DISCUSSION OF AMENDMENTS TO THE SPECIFICATION

Amendment/Response

Serial No. 09/830,388

FIG. 13

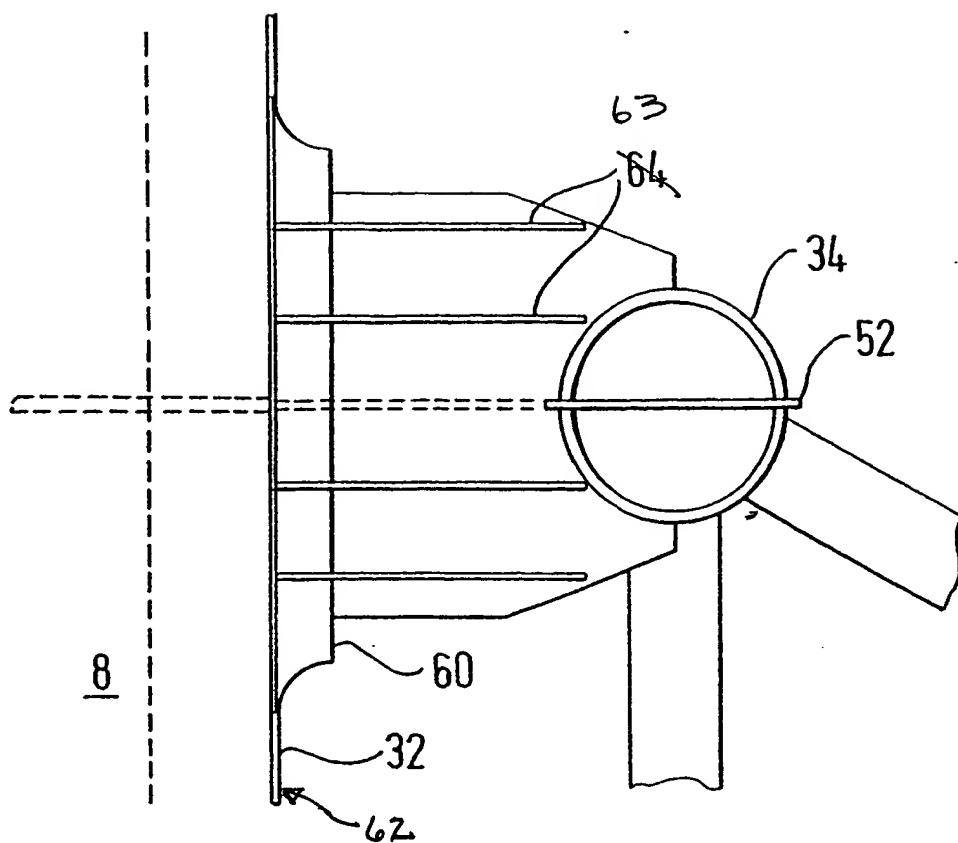
Figures 6 and 13 has been amended to address the objections raised by the Examiner in the Office Action on the top of page 3. If the changes to the Figures are acceptable to the Examiner, the Applicant will submit Formal Drawings incorporating these changes prior to payment of any issue fee.
